TECHNICAL INFORMATION

**CAMERA FIRMWARE**  
**V.10.1.2.4**  
CHANGELOG

The descriptions in this document are based on the firmware version **10.1.2.4**.

## Client-side Image Rotation for Vertically Oriented (Portrait) Scenes

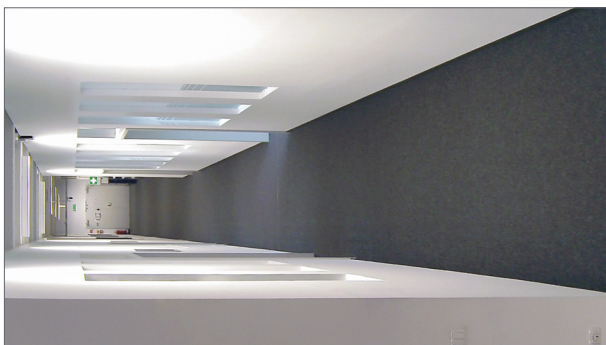
With the current firmware version, a new option for client-side image rotation has been added to the “Video” dialog. The set image rotation (90°, 180° or 270°) does not take place on the camera itself but will then be carried out by compatible Dallmeier software applications such as SMAVIA Viewing Client. The image rotation feature is useful, in particular, for monitoring vertically oriented (portrait) scenes such as long rooms (passages, hallways, corridors), streets and sidewalks, railway platforms or perimeter fences.

During the installation, the camera or lens/sensor unit is first rotated physically so that the scene is not captured in the usual aspect ratio of 16:9 or 4:3 (landscape format), but instead in an aspect ratio of 9:16 or 3:4, i.e. in portrait format. Thus, the full available sensor resolution can be used solely for important image areas and the recording of superfluous information on the image sides can be avoided.

With the new option for client-side image rotation, the camera image is automatically displayed correctly for the operator when the video material is evaluated.
